**BLUE MARSH DAM  
AND**

CONDITION REPORT.

DAM, OUTLET WORKS, SPILLWAY  
BERNVILLE PROTECTIVE WORKS.  
PERIODIC INSPECTION REPORT

INSPECTION & ACTION SUMMARY  
Periodic Inspection Report No. 2

BLUE MARSH LAKE  
INSTRUMENTATION PLAN

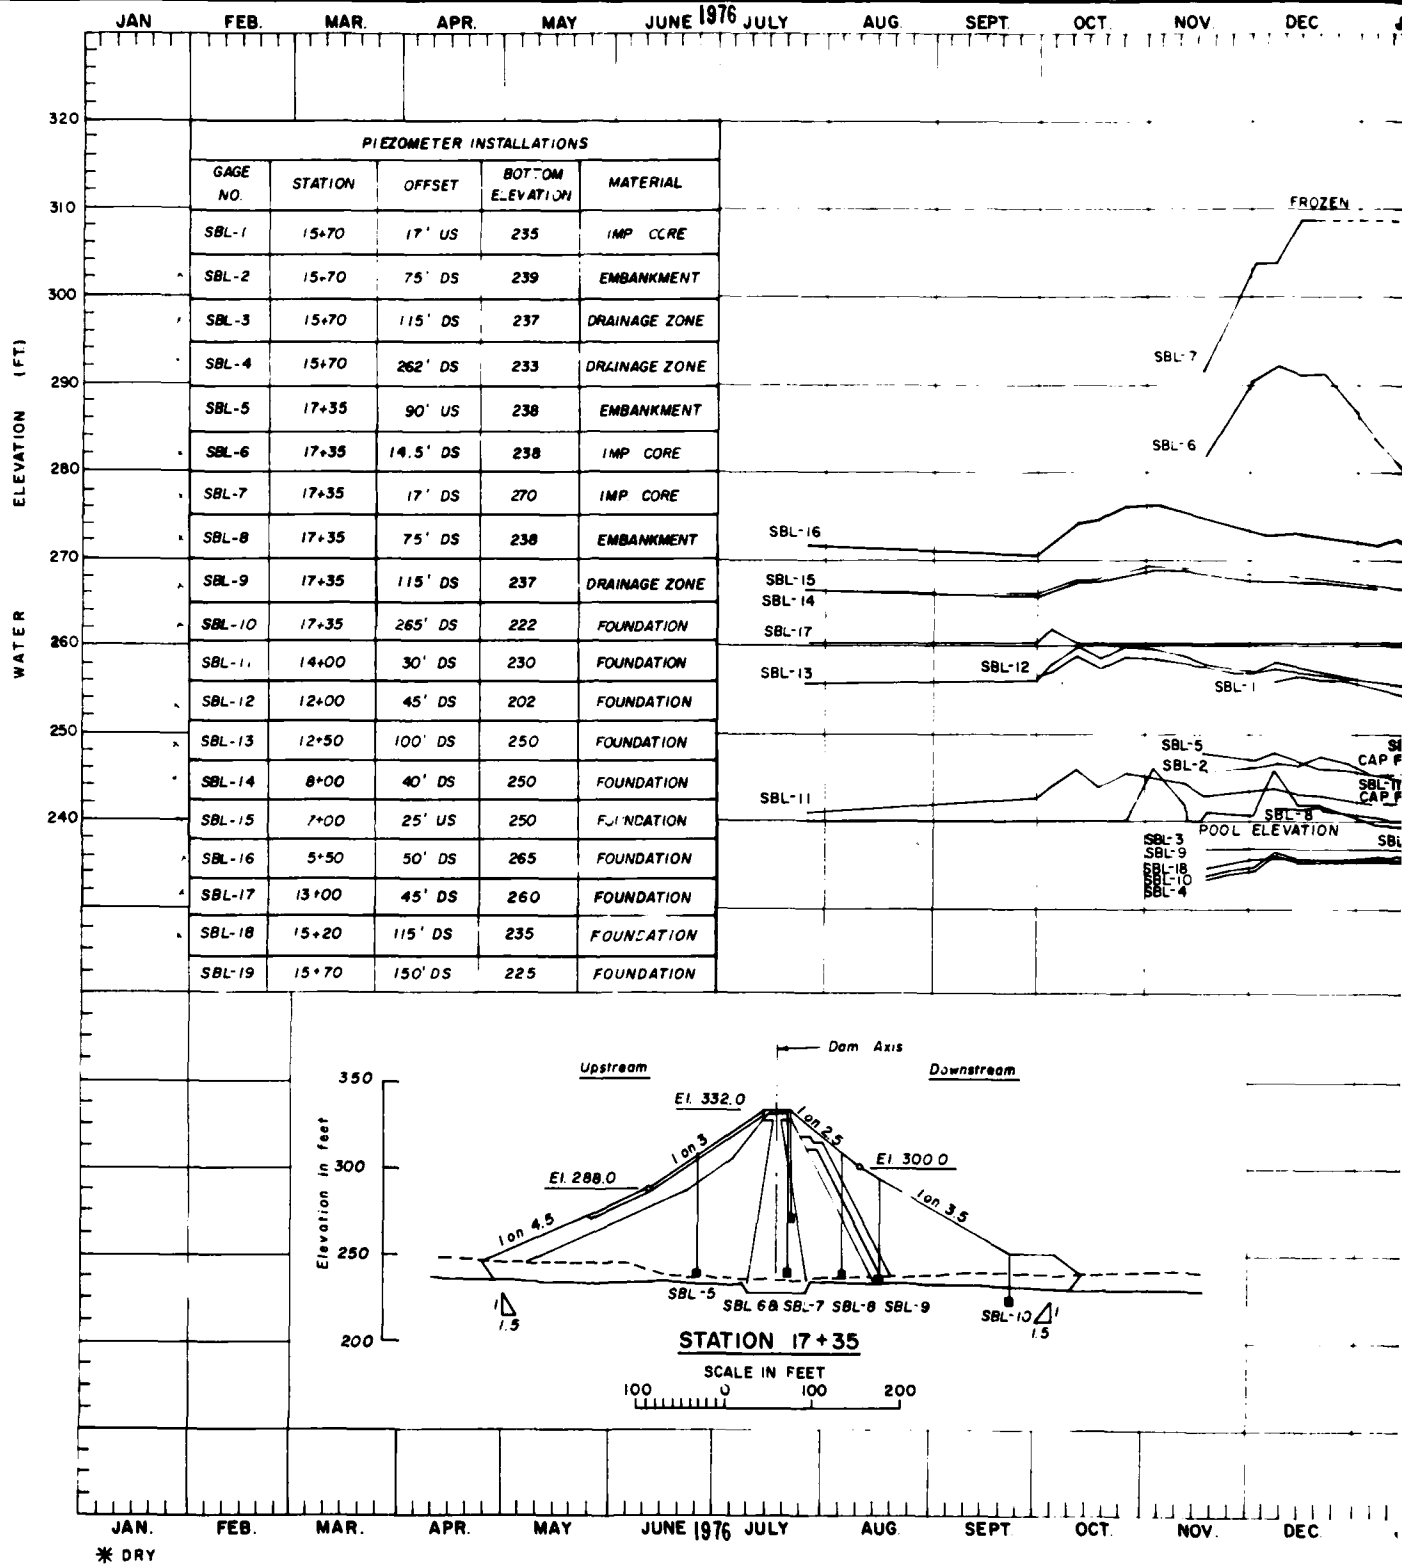
b. The seepage area noted during the first Periodic Inspection in the foundation at the downstream toe of the slope at Sta 8+00 (near piezometer SBL-14) was noted again during this periodic inspection. This wet area has shown little change in character, location or extent since the first periodic inspection which was performed prior to the filling of the reservoir. Several wet areas were also noted during these same two inspections along the upstream toe of slope on the right abutment between STA. 8+00 and 10+00. These upstream areas seem to be due to the ponding of surface water rather than seepage. The location and approximate extent of these wet areas are shown on Plate No. 1 (Instrumentation Plan). No action required.

Photo No. 5. Displacement of stilling basin posts and handrails  
- left side.

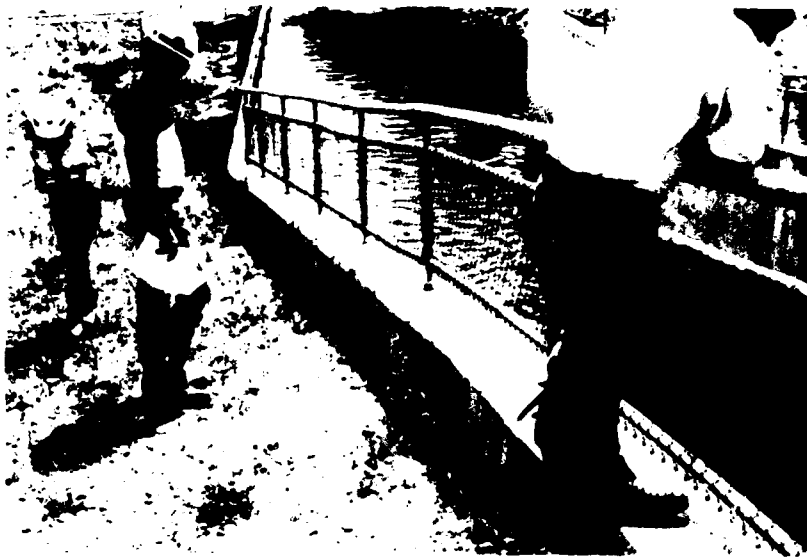
(2) Handrail posts on both chute walls have been forced up, resulting in bent handrails and spalling of concrete around the base of the posts. Upward displacement is approximately 2 inches at post with maximum movement. Freezing of trapped water below the grouted fence posts is the most likely cause of this phenomena. If movement continues, epoxy injection grouting at the posts or other measures may be necessary.
